STUDER

SERVICE INFORMATION SI 13/76

Ersetzen des Bandzählers an STUDER A80/VU-Geräten

Replacement of timing indicators on STUDER A80/VU machines

MASTER OSCILLATOR
PC CARD

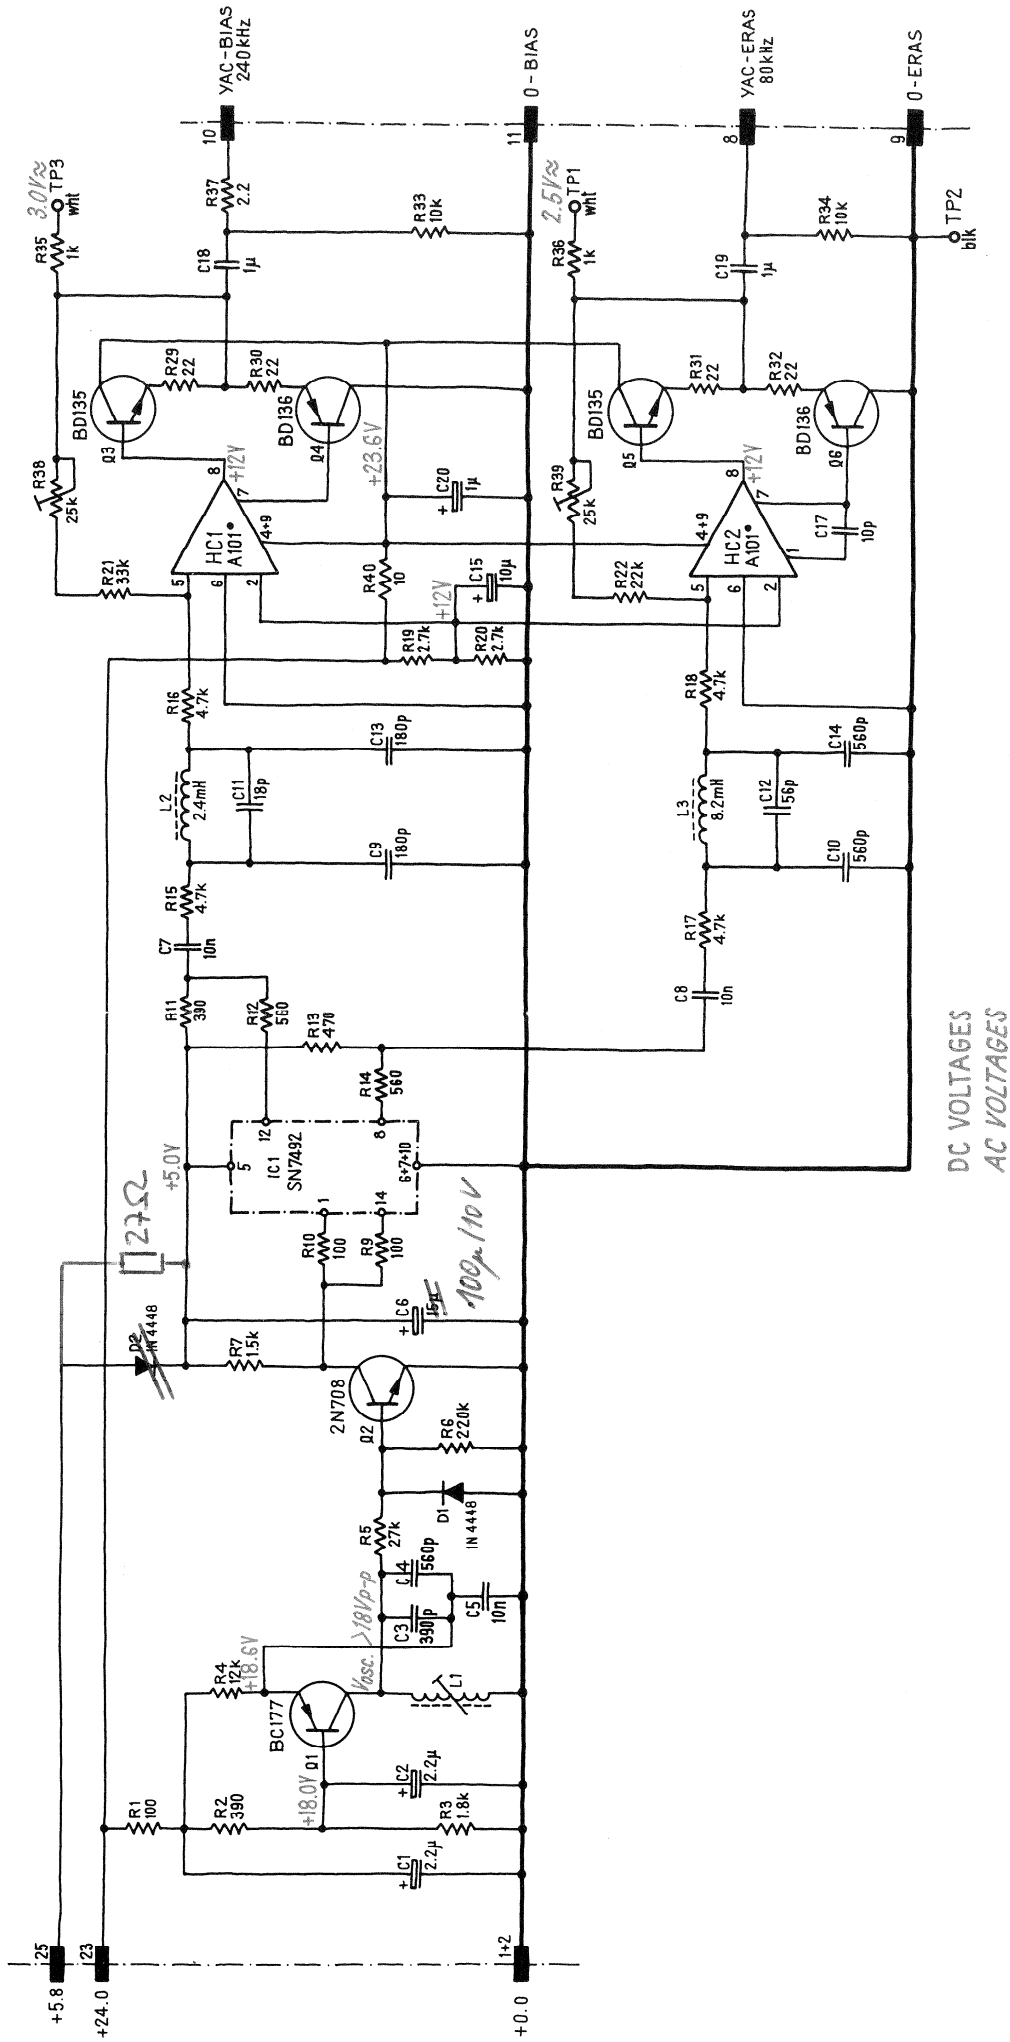
COMPONENTS TO BE REPLACED

CHANGE FOLLOWING COMPONENTS:

- D2 to be replaced by 27Ω resistor
- C6 to be replaced by 100pF capacitor
